## REMARKS

Favorable reconsideration of the above-identified application is requested in view of amendments made herein and remarks presented below. Claims 8-14 remain pending, Claims 1-7 having been previously canceled.

**AMENDMENTS TO THE DRAWINGS**

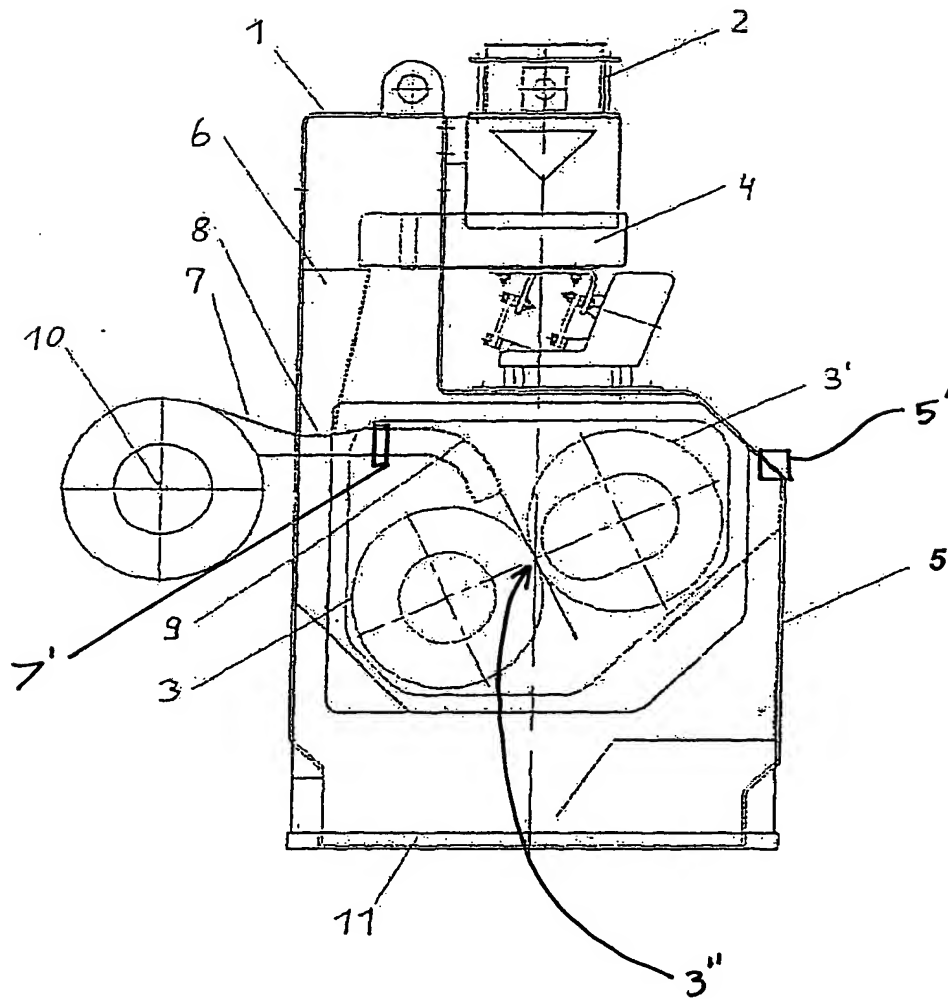
The Office action objects to the drawings because they do not illustrate a "pneumatic conveying device," a "roll gap," an "air connection," an "aspiration connection," or that a "feed pipe can be swiveled or pivoted," as recited in various claims. That objection is traversed for at least the following reasons.

A pneumatic conveying device is illustrated in the drawings, *e.g.*, parts 7-10, and a roll gap is illustrated in the drawings, *e.g.*, the area between rollers 3 and 3'. Those features would have been understood by a person of ordinary skill in the art. However, to address the concerns raised in the Office action, such is now specifically labeled with reference numeral 3" to address the Examiner's concerns.

An aspiration connection is now illustrated in the drawings as a box and is labeled by reference numeral 5'.

A swivel or pivot portion of a feed pipe, *i.e.*, a feed pipe that swivels, is now included in the drawings as a box and the swivel or pivot portion is identified by reference numeral 7'.

*One drawing replacement sheet is attached and includes Figure 1. The drawing replacement sheet replaces all other drawing sheets in this application. The drawing replacement sheet includes an amended Figure 1, the changes being the addition of a swivel or pivot 7', an aspiration connection 5', and a roll gap 3". An annotated drawing sheet showing changes is attached.*
